# Work Order ID 74246

Item Name: Crosstube Turning DetailL

<b>DART AEROSPACE LTD</b>	<b>Work Order:</b> 74246
<b>Description: Crosstube Assembly (206L High Fwd)</b>	<b>Part Number: D206-667-143</b>
<b>Inspection Dwg: D206-667-143 Rev: C</b>	<b>Page 1 of 1</b>

DRAWING NO. D206-667-143	TITLE CROSSTUBE ASS'Y (206L HIGH FWD)	REV. C	DART AEROSPACE LTD ENGINEERING ORDER		D.E.O. NO. D206-667-143-C-1	SHEET NO. SHEET 1 OF 1	SCALE NTS
DRAWN 9P	CHECKED ASS	MFG. APPR. [Signature]	APPROVED MD	DE APPR. [Signature]			
DATE 11.07.15	DATE 11.07.20	DATE 11.07.21	DATE 11/07/21	DATE 11.07.21

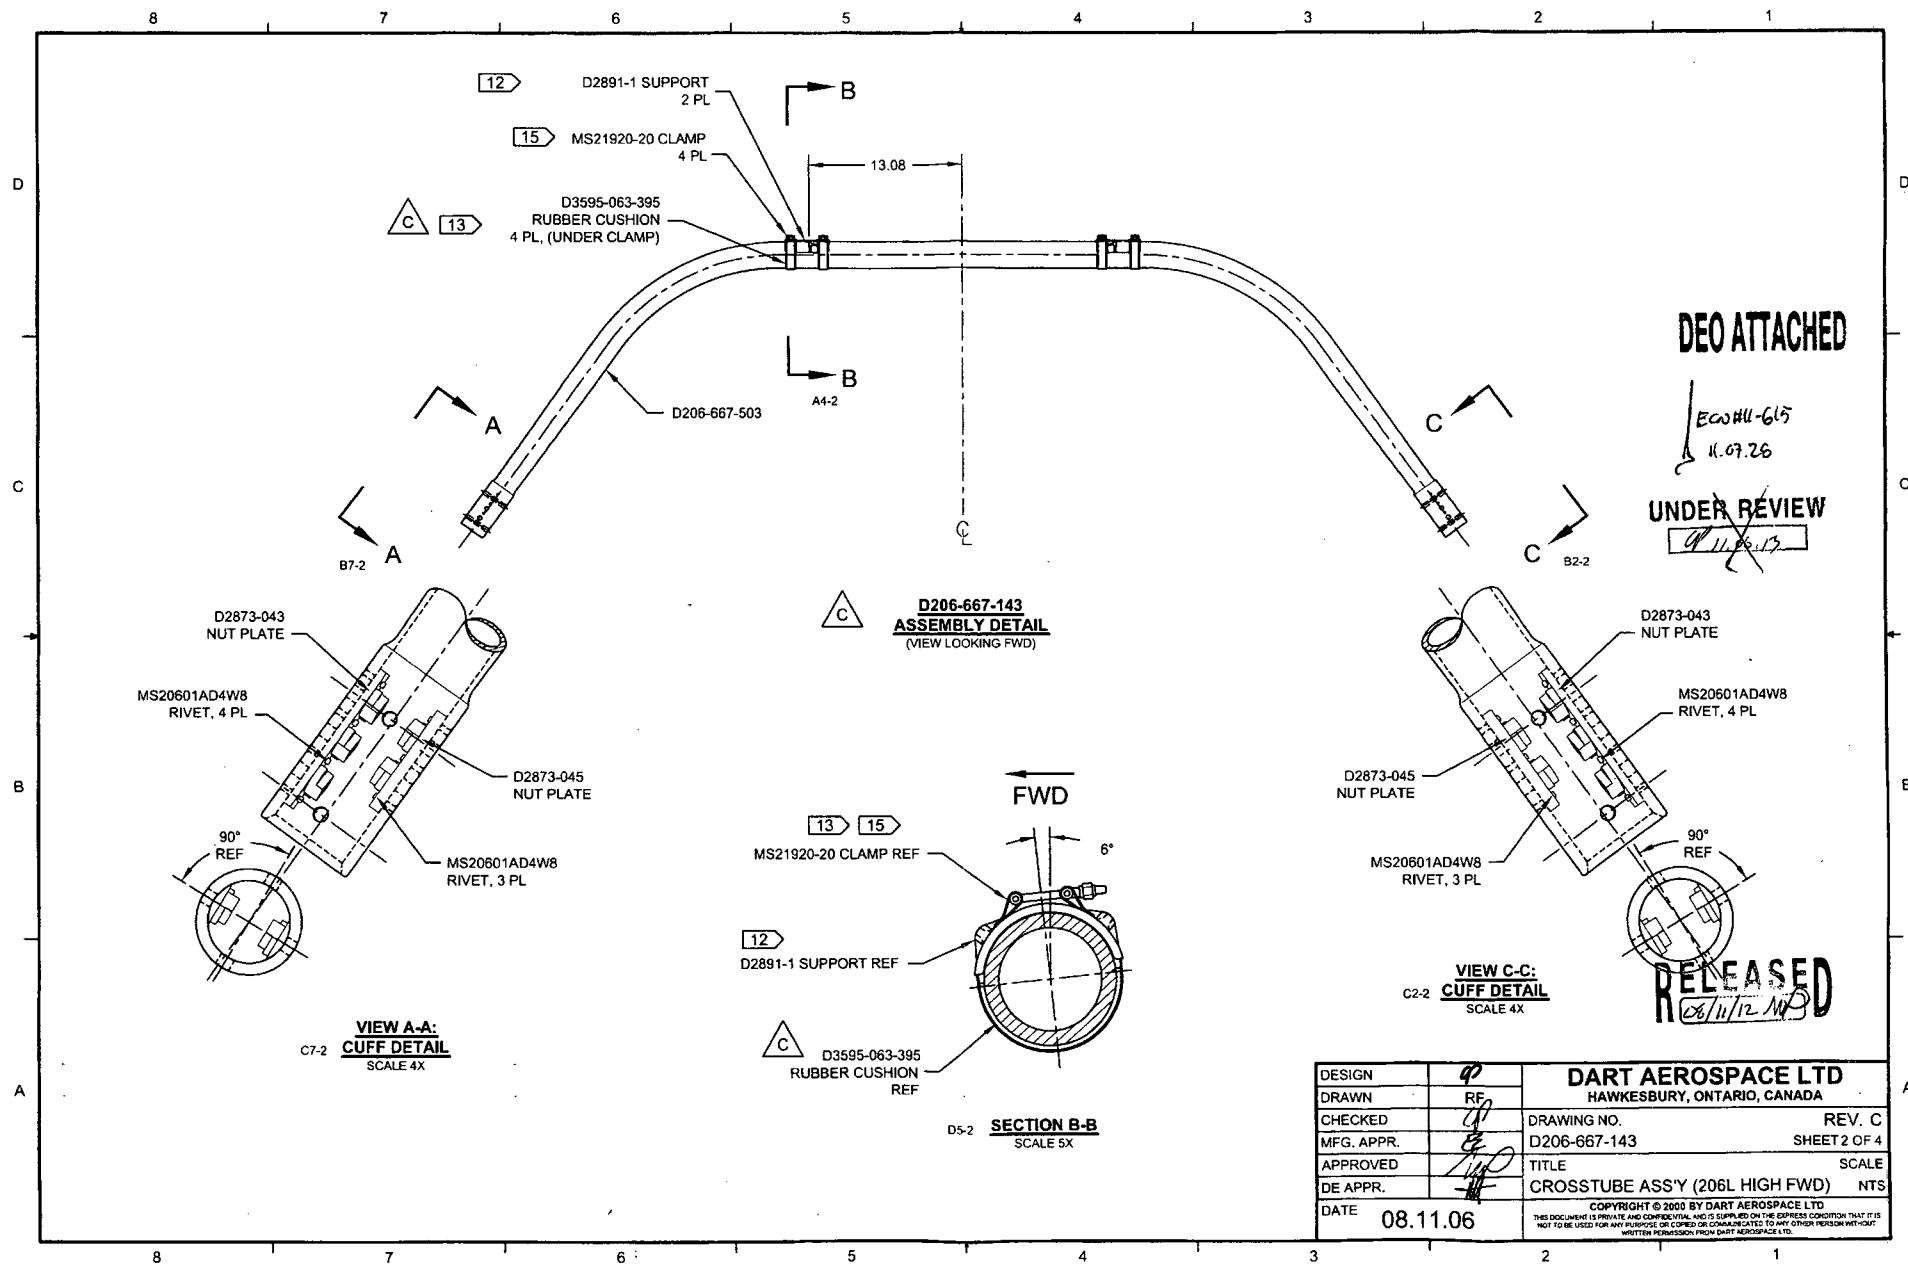
REPLACE MAGNOBOND WITH PROSEAL

NOTE 12 & 15, SHEET 1 IS AMENDED AS FOLLOWS:

Item	Qty	Part Number	Description
9	A/R	PROSEAL 890 B-2	SEALANT, AMS-S-8802 CLASS B-2

- 12) TO INSTALL D2891-1 SUPPORT: ABRASE MATING SURFACE OF SUPPORT AND CROSSTUBE WITH 180-GRIT SANDPAPER AND REMOVE RESIDUE WITH MEK (OR EQUIVALENT). APPLY A 0.04" TO 0.07" THICK LAYER OF PROSEAL 890 CLASS B-2 (OR AMS-S-8802 CLASS B-2) SEALANT TO MATING SURFACE OF SUPPORT.
- 15) TORQUE CLAMPS 80 TO 100 IN-LB. ENSURE AT LEAST 1.5 THREADS SHOWING IN SAFETY AND THAT NUT HAS NOT BOTTOMED-OUT AFTER TORQUING. **PRIOR TO PACKAGING, RE-CHECK TORQUE ON CLAMPS AFTER PROSEAL 890 SEALANT HAS CURED FOR 72 HOURS.**

**TURNING DETAIL**

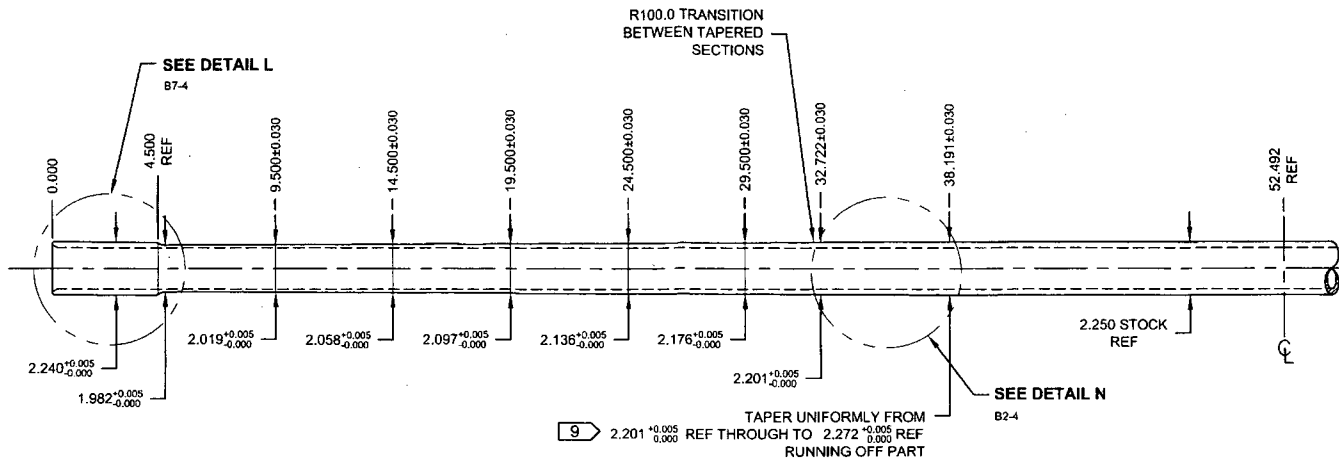
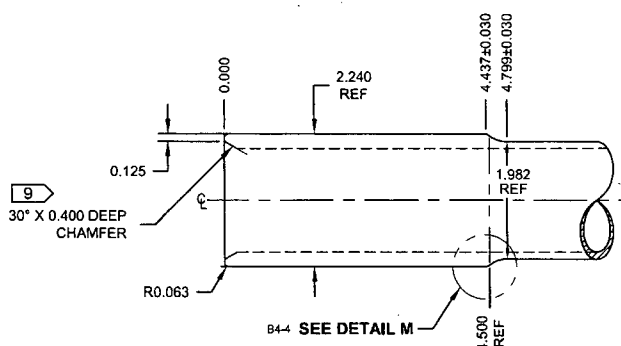
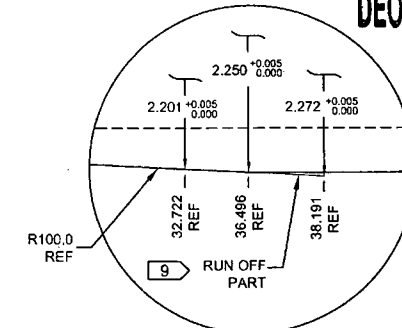
FOLIO REV: ~~BA~~ AB

DWG REV: ~~C~~ E
